RFQ NUMBER
DEP15421

LINE	QUANTITY	UOP	CAT. NO.	ITEM NUMBER	UNIT PRICE	AMOUNT
***** ADDENDUM NO.1 *****						
ADDENDUM ISSUED FOR THE PEACH RIDGE COMPLEX PROJECT IN MCDOWELL CO. WV, TO DISTRIBUTE THE PRE-BID SIGN-IN SHEETS, ADDITIONAL SPECIFICATIONS, ADDITIONAL DRAWINGS REVISED BID SCHEDULE, AND THE Q/A RESULTING FROM THE MANDATORY PRE-BID ON 06/08/2011.						
BID OPENING DATE & TIME ARE EXTENDED FROM 07/06/2011 TO 07/20/2011 AT 1:30 PM.						
***** NO OTHER CHANGES *****						
0001	1	JB		962-73		
RECLAMATION: RESTORATION OF LAND & OTHER PROPERTIES						
***** THIS IS THE END OF RFQ DEP15421 ***** TOTAL:

DEP15421
Peach Ridge Complex
Addendum # 1

OVERALL PLAN
PEACH RIDGE COMPLEX
MCDOWELL COUNTY, WEST VIRGINIA

SITE PLAN
PEACH RIDGE COMPLEX
McDOWELL COUNTY, WEST VIRGINIA

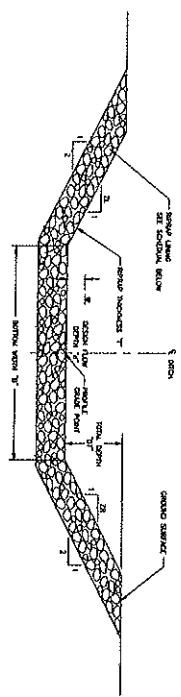
Item 2: The construction work limits for the upper bench (Trail # 62) and the lower bench (Trail # 67) have been extended from the intersection to the designated work sites. Only one bench (trail) may be closed at a time. The contractor is to coordinate access to the benches (trails) with the Hatfield & McCoy Trail Coordinator. The contact information is: John Fekete @ 304-687-9875 (cell) and 1-800-592-2217 (office). Revised sheets have been included to show the construction work limits.

SUPER SILT FENCE DETAIL
 NO SCALE

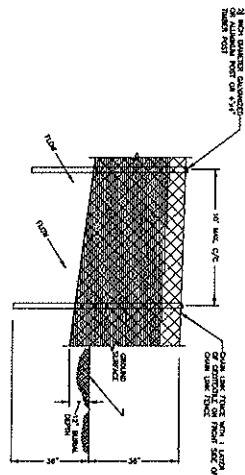
Item 8: Super silt fence has been added to the plans.

- Bid Sheet (a bid item for super silt fence has been added; the bid item for a sediment trap has been deleted; a bid item for asphalt pavement overlay has been added)
- Specification for Bid Item 12.0, Asphalt Pavement Overlay, has been added.
- Page 27 of the Specifications has been modified to show the deletion of the sediment trap bid item, and the addition of the super silt fence bid item
- A composite plan sheet is included to show the revised construction work limits and the area to receive the asphalt overlay.
- A revised site plan sheet is included to show the revised work limits, the deletion of the sediment trap, and the addition of the super silt fence.
- A detail sheet is included to show the asphalt overlay and heel-in details.
